Approval of Reserved Matters Consultation

Application Number: 251457

Site Address: Parcel 8, Finchwood Park, Sheerlands Road, Arborfield, Wokingham, RG40 4QY

MEMORANDUM

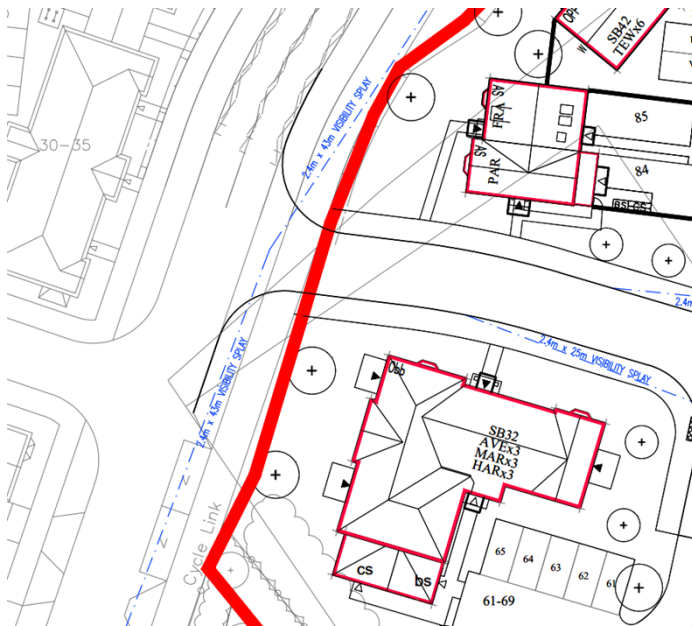
1. Drawing No. PLN-8-4005 (Rev. E) dated 28th February 2025 demonstrates visibility splays of 2.4m x 25m at internal site access junctions. This complies with the Manual for Streets visibility standard for the proposed 20mph speed limit. Corner radii of 4m and 6m are displayed for the access road north (hereafter 'A(N)') and south (hereafter 'A(S)'), respectively.

2. As A(N) provides access for 14 households, the minimum access road width is recommended to be 4.8m. As this road also provides access for refuse vehicle, the minimum width of the road should be no less than 5m.
3. The LHA require visibility to be measured using a 2.4m setback from the give-way line for the site access. The visibility splay has been measured from 1.6m at the primary site access junction, as shown on Stuart Michael Associates Drawing No. PLN-8-4005-Rev-E titled 'Visibility Splays Parcel 8 dated Feb 2022'. Any landscaping within these splays will need to be maintained to a maximum height of 0.6m and therefore it is crucial the splay is correctly demonstrated in accordance with MfS requirements.
4. The LHA require provision of a tabled crossing over the primary vehicle access junction to prioritise cyclists using the cycle link which passes the site.

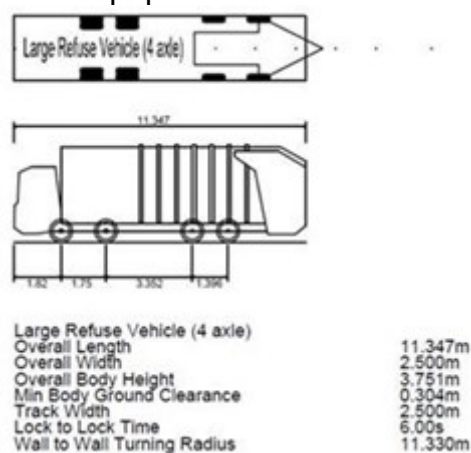
5. The LHA require the provision of physical speed reduction features along the proposed adopted carriageway. This section of straight road is 5.5m wide and c.100m long, which would result in vehicles exceeding the target speed of 20mph, set within the Wokingham Living Streets Guide (2019):
 - Features reducing vehicle speeds should be provided at 50-80m centres. This could take the form of traffic calming, such as speed cushions or built outs.
 - The design should naturally convey appropriate design speeds to drivers, with a target speed of 20mph specified in the Wokingham Living Streets Guidance(Link:<https://www.wokingham.gov.uk/sites/wokingham/files/2023-07/Highways%20design%20guide%20for%20developers.pdf>).

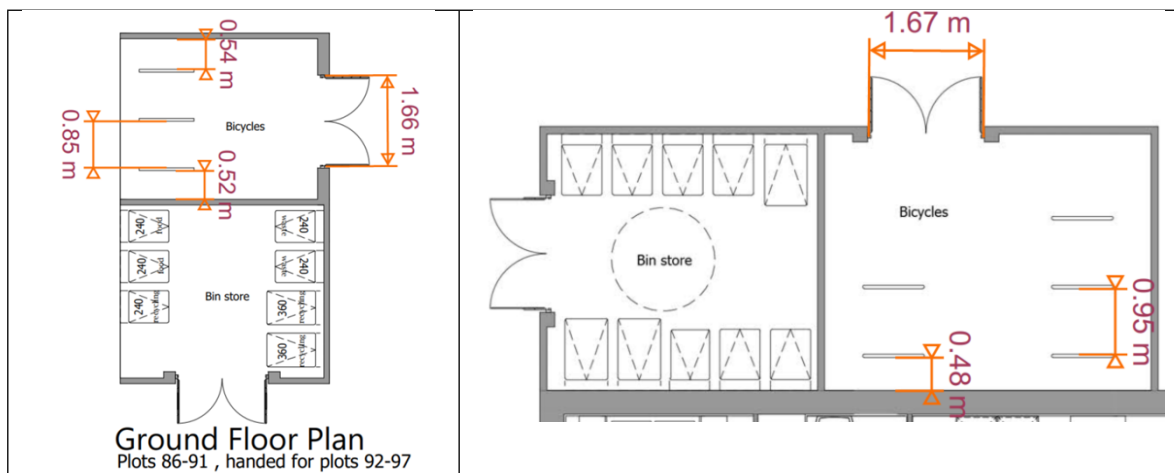
17. A minimum of 6m driveway clearance has been provided at the parking court of the flat blocks, for vehicle manoeuvring at forwards gear when leaving the highway. This is welcomed.

18. The proposed unallocated parking spaces are clustered around the flat blocks SB42, and similarly visitor parking spaces are clustered around the parking court opposite to Plots 70 and 71. The LHA recommend the visitor and unallocated spaces to be better distributed across the site.

19. The applicant shall explore the possibility for providing the parking spaces for Plot 75 on the same side of the dwelling.
20. To prevent additional parking that obstructs the turning head, it is recommended to reduce the driveway length for Plots 76-79, between the edge of carriageway and the garage, to no more than 13m.
